**TOWN OF ACTON
NOTICE OF PUBLIC HEARING**

Subject: Amendment to the Existing Traffic Rules and Orders

**CONCEPTUAL PARKING PLAN
WEST SIDE OF SPRUCE STREET
ACTON, MASSACHUSETTS**

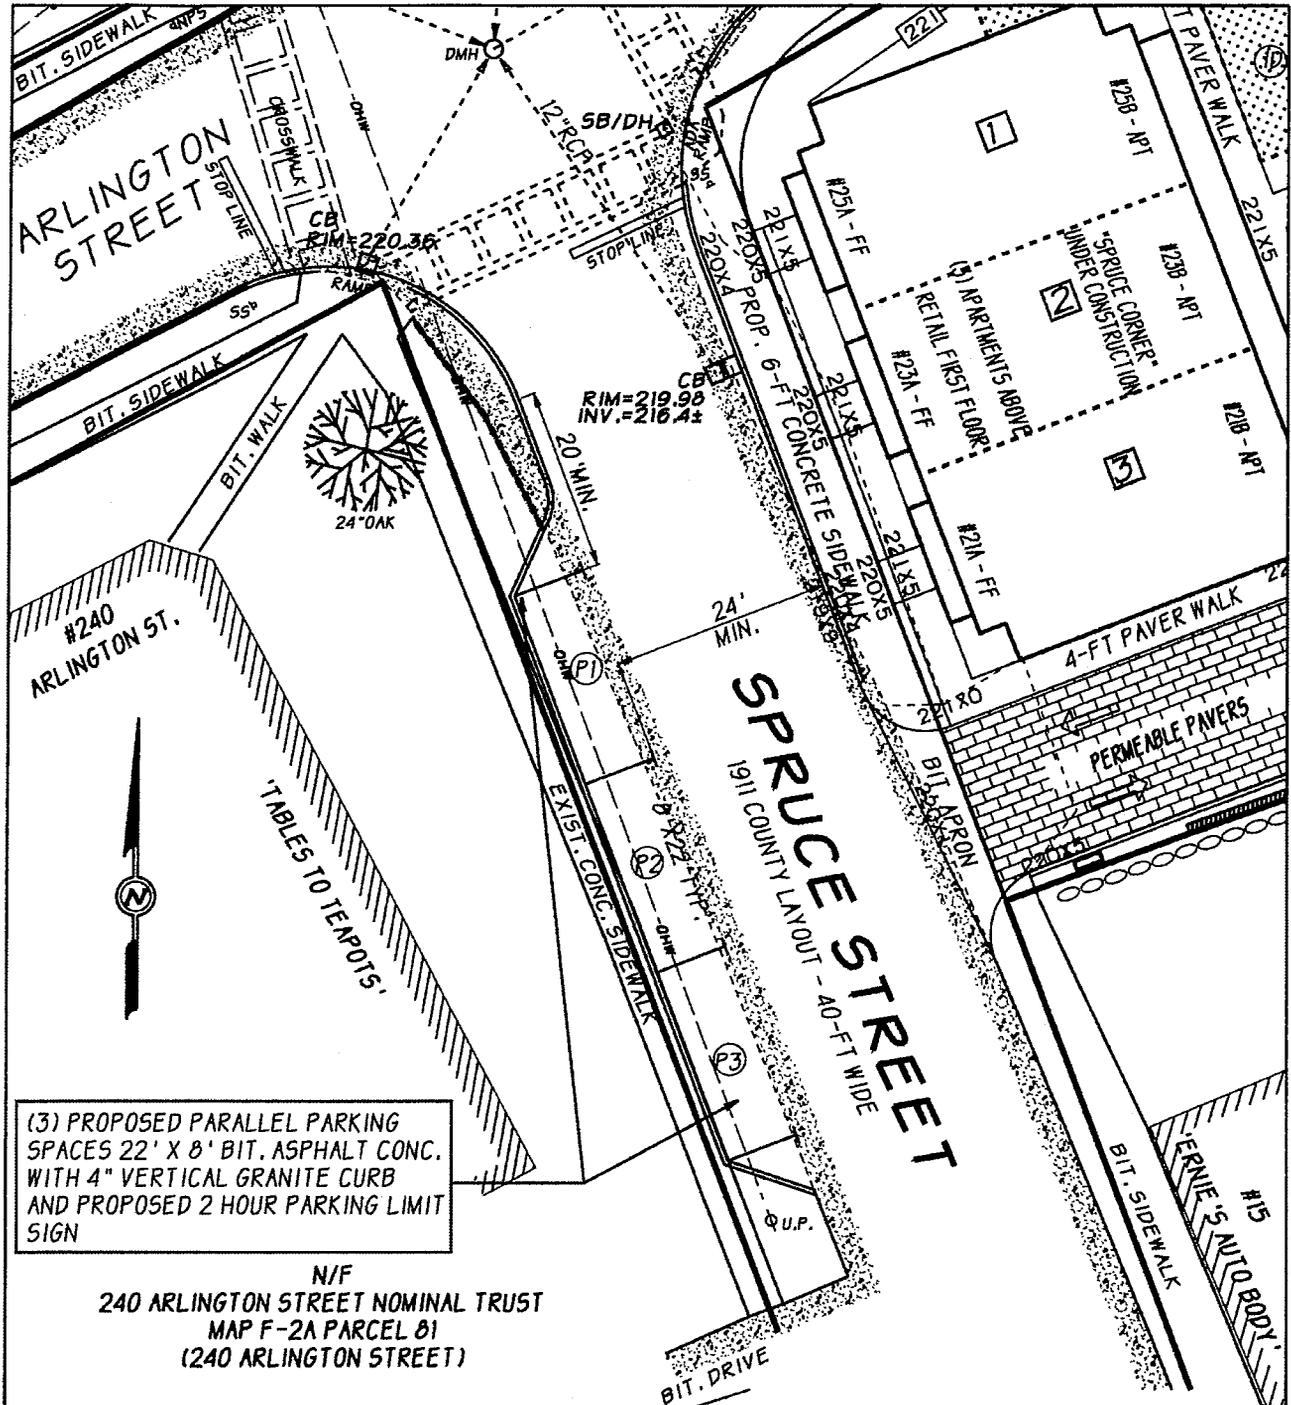
- The road pavement for Spruce Street will be no less than 24 feet wide.
- The three (3) proposed parking spaces will be 22 feet in length by 8 feet wide. This conforms to the parking standards established in the Zoning Bylaw.
- The proposed parking will have a 20 foot minimum offset from the paved intersection rounding at Arlington Street. This will conform to the TR&Os general parking prohibition at/near intersections.
- These spaces will remain open to the public
- The new parking spaces are shown to remain entirely within the Spruce Street layout

The relocated granite curbing should not impact the existing 5 foot wide concrete sidewalk along Spruce Street.

The typical cross-section for the bituminous concrete should, at a minimum, comply with the standards set forth in the Subdivision Rules and Regulations for a street.

The granite curbing should be installed in the same manner as approved on their Spruce Corner development plans.

The applicant should be responsible for the pavement markings to delineate the three (3) parking spaces.

I would agree that the Town should approve a time restriction for these spaces. If these parking spaces are approved, the Engineering Department will prepare an amendment to the existing Traffic Rules and Orders to remove the No Parking Restriction at this location and establish a 2-hour parking restriction to be consistent with the other streets in the area. The Town would then furnish and install the signage for the parking restriction.

I recommend that the parking spaces be approved to help mitigate some of the parking issues that are occurring in West Acton Center. It is also my understanding that the applicant is also working on modifications to the Spruce Corner plans to provide additional parking spaces on their own property.
